UNIVERSITY OF OREGON
 Student Recreation Center
 REFRESHMENT) MULTIFUNCTIONAL ROOM
 = 2000 sq ft
 = 1800 sq ft

RDE - PA
 STUDENT RECREATION CENTER
 GROUP EX
 1000 sq ft - 1000 sq ft
 6,000 sq ft

OPTION 1

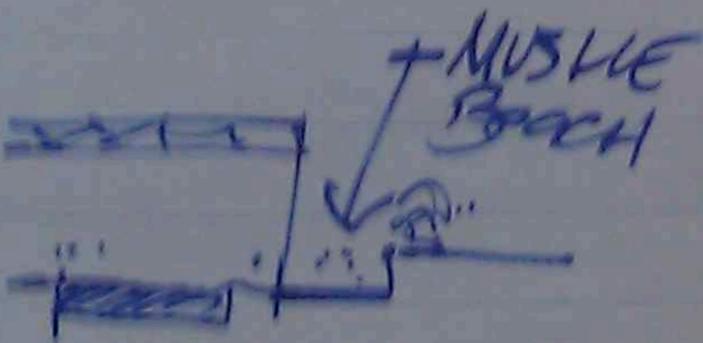
LIKE 3 STORY
STACKING.

LIKE ROOF GARDEN

ROOM FOR EXPANSION

EXPANSION AT BACK

NO EAST ACCESS.

NO EXPANSION OF TRACK

DOWN/UP FREE ZONE
ROUTE

POOL IN WAY
OF EAST ACCESS
TO FIELDS

OUTDOOR SPACE
NOT COVERED

OPTION 4

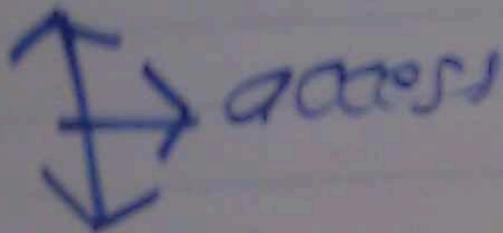
FREE ZONE
ACCESS TO
OPTION 4

LIFE STACKING

DOWN VIEW
ON POOL

IMMEDIATE VIEW
TO FITNESS

GENERAL COMMENTS

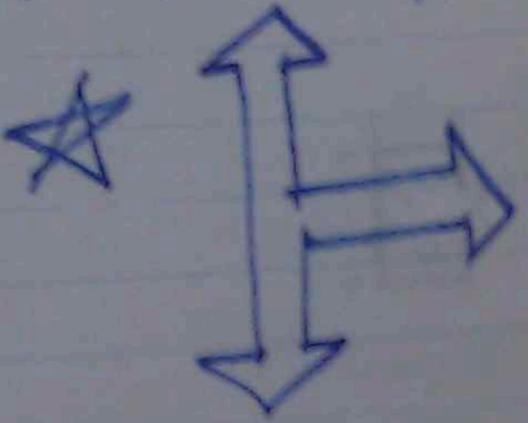
FLAT ROOFS "SCARE ME"

BWARE OF HARD TO SUPERVISE SPACES

- ★ FREE ZONE ACCESS IN ESSINGER, TO.
 - ALL OFFICES
 - H.P. CL. # ALL H.P. SPACES
 - CONF ROOM (NEW)

MEMBERSHIP SERVICES TO DOWN STAIRS

A ROOF AREA NEEDS TO BE COVERED.

★ 3 STORY SCHEME = PREFERRED!

★ NEED VIEWS INTO THE POOL

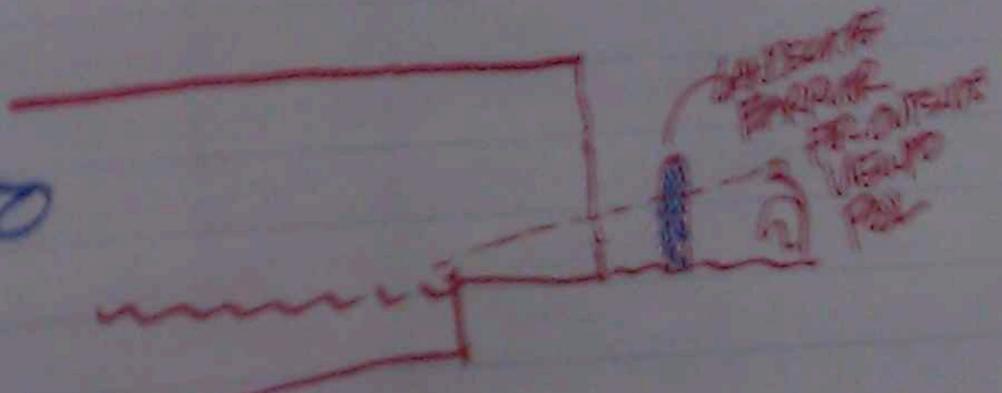
★ NO TOWER/Etc bldg

COURT #1

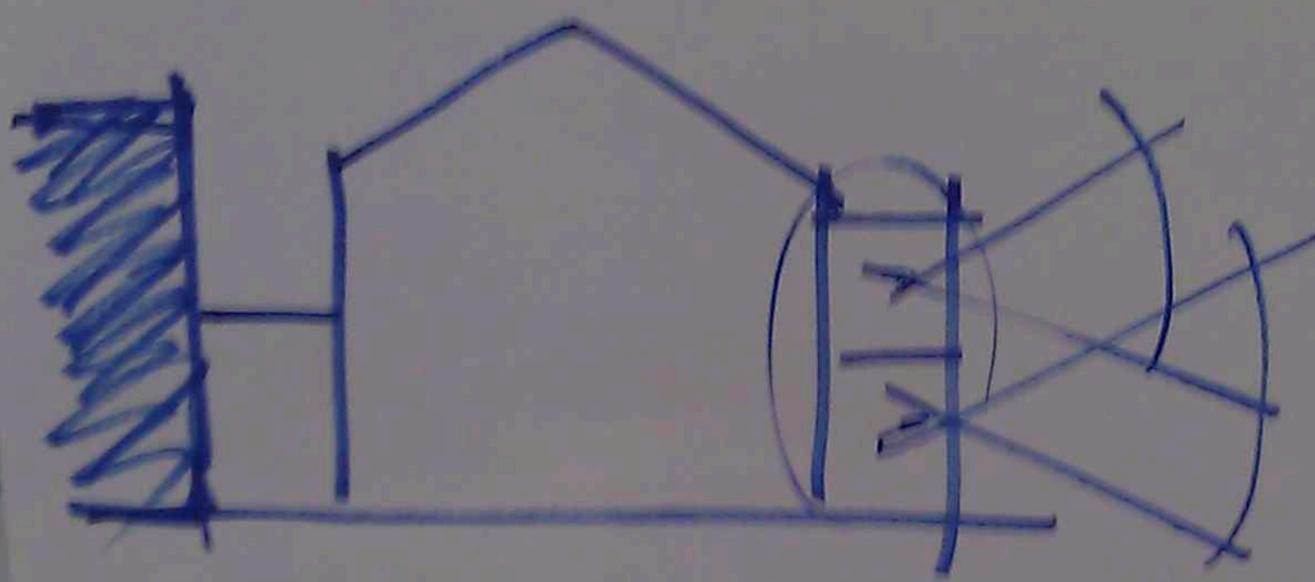
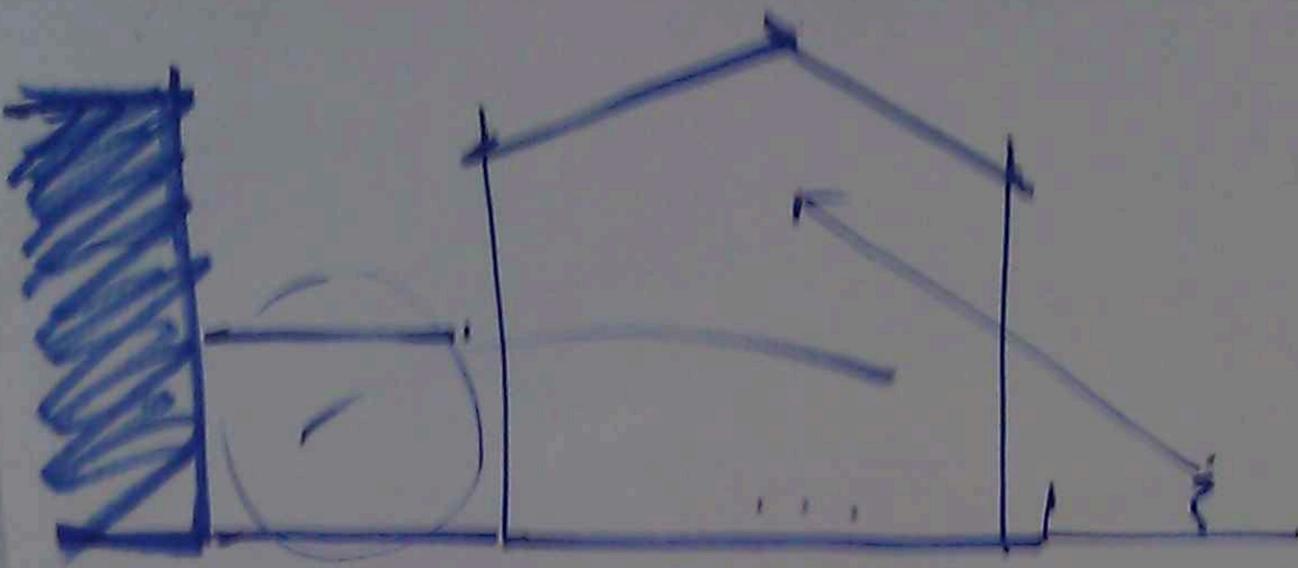
★ NO TUNNELS & bldg
